## ABIB-9607

### Component Change for D461/521/581/601/651/652 Series Axles.

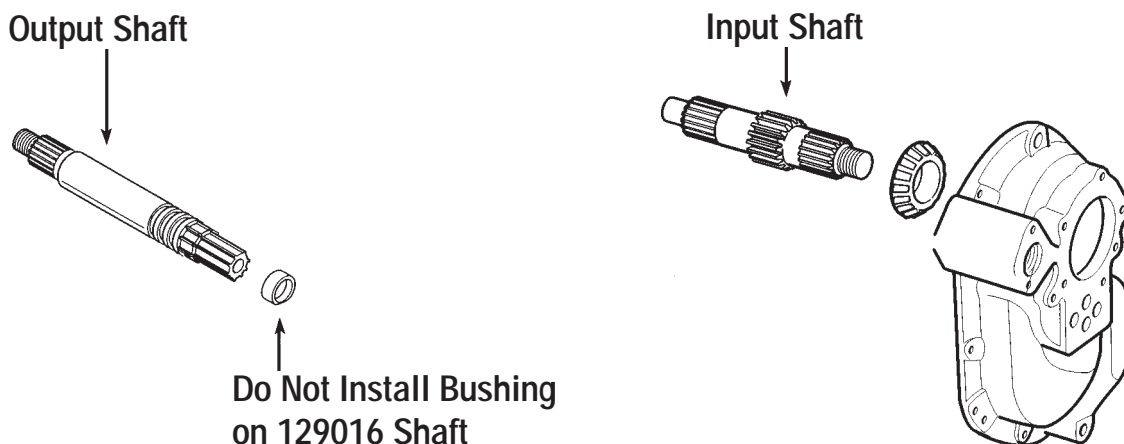
Effective September 21, 1994 the following component change took place on the above models. Bushings are no longer used in the end of the output shaft. The chart below identifies the old style part numbers and the current design part numbers related to this change, both old and new parts are inter-changeable with each other.

**NOTE:** When servicing these models, be sure to identify the output shaft by part number before attempting to install a bushing. Do not install a bushing onto the 129016 output shaft.

Service Kit Part No.	Description	Old Design Shaft Part No.	Part Number Of New Shafts
122418	Input Shaft Kit	119990	129017
122419	Output Shaft Kit	119991*	129016
